27.10.2020

Our Ref: 34807-002-01
Your Ref: MCUC 2020/3524/1

Information Request Response
Development Application for Material Change of Use – Retirement Village
111-119 Port Douglas Road, Port Douglas – Lot 3 on RP729991

PROPOSED DEVELOPMENT ON LOT 3 OF RP72991	
STORMWATER DRAINAGE CATCHMENT	
POST-DEVELOPMENT SCENARIO	
DRAWING NO.	188-002-SK11
REVISION	1

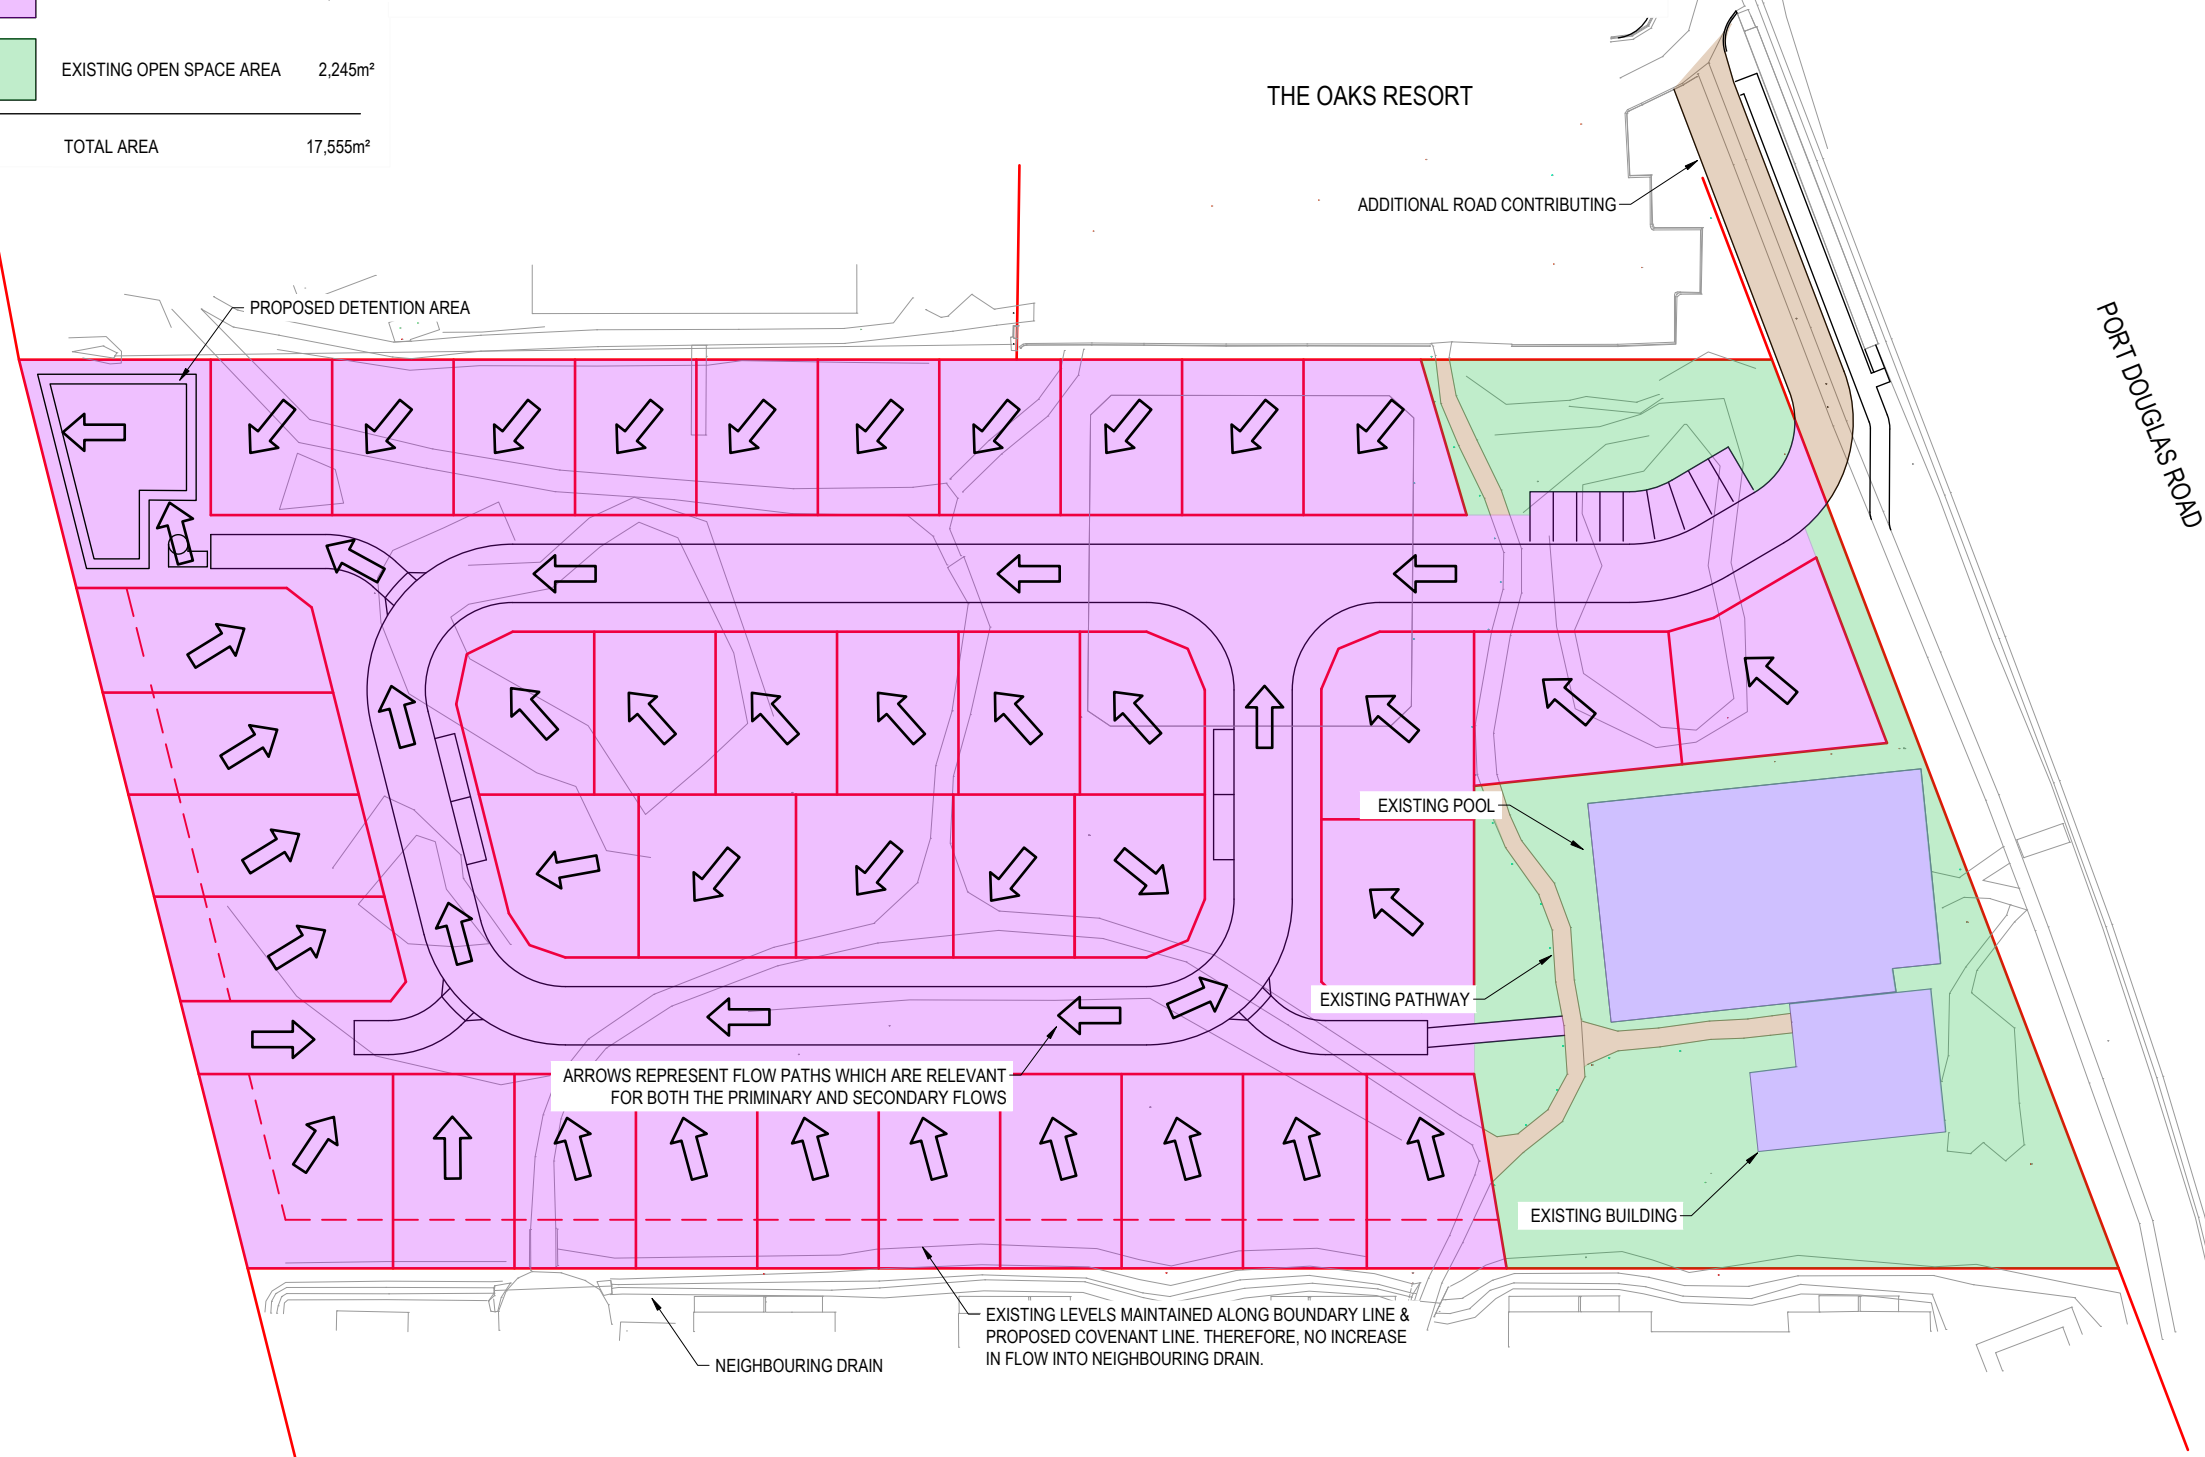
1. *Undertake a local drainage study of the site to determine the drainage impacts on upstream and downstream properties and the mitigation measures required to minimise such impacts. In particular, the study must address the following:*
 - a. *The contributing catchment boundaries;*
 - b. *The extent of the 1% AEP (100 year ARI) flood event in relation to the site both pre- and post-development. Note: the operation of the adjacent open drains needs to be considered in addressing this point;*
 - c. *Primary and secondary flow paths for the 5, 10 and 100 year ARI flood events. Note: advice on the flows discharging from the adjoining site to the south via its internal road system and the open drain along the common boundary must be considered in providing a response to this item. Cross sections showing the pre and post development drain profile must be included;*

Drawing 188-002-SK11 identifies the site catchment changes due to the development, also identifying the additional section of road that will drain to the site.

The post-development 100-year flood event was also calculated adopting the rational method in accordance with the procedures nominated within Section 4 of QUDM. Referencing drawing 188-002-SK11, the catchment contributing to the proposed outlet is 17,555m². Calculation of Q100 flow from the catchment is as follows:

- fraction impervious adopted at 0.67 (refer drawing 188-002-SK10 for details)
- 1 hour 10-year intensity for Port Douglas = 81.16mm/hr (refer FNQROC IFD Chart 18)
- C₁₀ co-efficient of runoff = 0.84 (refer QUDM Table 4.5.3)
- Frequency factor = 1.20 (refer QUDM Table 4.5.2)
- Therefore, C₁₀₀ = 1.20 x 0.84 = 1.00 (= 1.01, but cannot have more than 100% runoff)
- Time of Concentration = 15 minutes (adopting QUDM recommended standard inlet time for urban residential areas where average slope of catchment is up to 3%)
- 15-minute 100-year intensity = 220.51mm/hr (refer FNQROC IFD Chart 18)
- Adopting the rational method in accordance with Section 4.3 of QUDM,

Primary and secondary flow paths for the 5, 10 and 100-year ARI events are all identical and are identified on drawing 188-002-SK11.
